# Fire Risk Assessment

Property assessed: A Lister Court Nightingale Avenue  
London HA1 3GX

Client: Network Homes Ltd

FRA Inspection Date: 04/09/2020  
FRA Issued to Client: 21/10/2020  
FRA valid to: 21/10/2021  
FRA completed by: Savills (UK) Ltd,  
33 Margaret Street, London W1G 0JD  
T: 020 7409 8737  
E: [fireriskhousing@savills.com](mailto:fireriskhousing@savills.com)

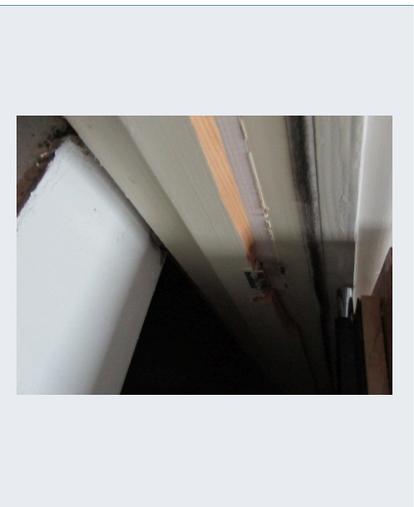
- Known	12		
- Potential	12		
Priority	C	Due Date: 21/04/2022	Client Status: Assigned
Question	O.2	<p>Comment: Fire door signage is not considered adequate:- The following fire doors are provided with the wrong signage: A03, A02, A05, A14. - The fire door signage in situ should be replaced with 'Fire door keep locked' signage. The following fire door require 'Fire door keep locked' signage: A04, 041, A13, A11/A12, A22, A33, A32. (Both openable doors within the double door cupboards will require adequate fire door signage) The following fire doors require 'Fire door keep shut' signage to both sides of the doors at eye level: 002-006 lobby door, Ground-floor - stairwell door.</p>	
Section	Fire Safety Signs and Notices		
Action ID	544411		
Quantity		<p>Recommendation: Provide 'Fire door keep shut' notices to common area fire doors as noted.</p>

Question - G.6: Are all other house-keeping issues satisfactory? No

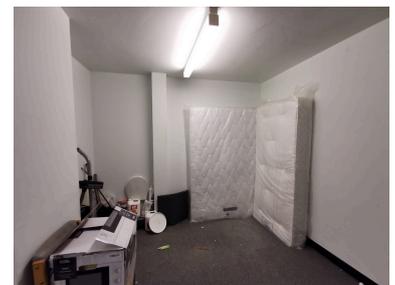
Comment: Previous comment - A number of storerooms were identified as having excessive amounts of storage/fire loading within.

Question - Q.3: Are services risers, shafts, ducts and cupboards in the common area appropriately enclosed with fire resisting construction and adequately fire-stopped?

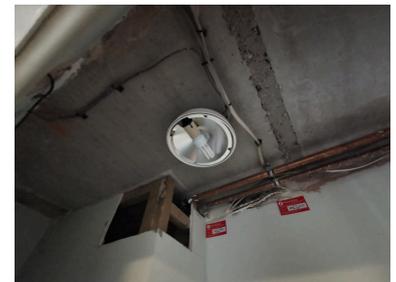
Comment: The bedroom service riser cupboards on the ground, first and second-floors appear to have no internal lining provided within the cupboards and above the door. Network Homes confirmed previous recommendation is complete; to check all risers are suitably fire stopped - (All bedroom riser cupboards have been fire-stopped to the floor) The top floor bedroom riser cupboards have been fire stopped to the ceiling and above the door (Internally) to an adequate standard. Additional compartmentation breaches were noted within the following cupboards at the time of the assessment, they are as follows: Ground-floor: A03 - damage to boxing. Second-floor: A26 - to high-level wall and ceiling around pipe-egress. A05, A15, and the externally accessed bike store should be accessed and inspected for adequate fire-stopping to the walls and ceiling.

Recommendation: The plasterboard panels and sections above/either side of the bedroom riser doors (Internally) where pipework and cables run to be fire stopped using fire-resisting materials to ensure 60 minutes of fire resistance between the cupboard and communal areas. Any fire-stopping works to be undertaken by a competent passive fire engineer.
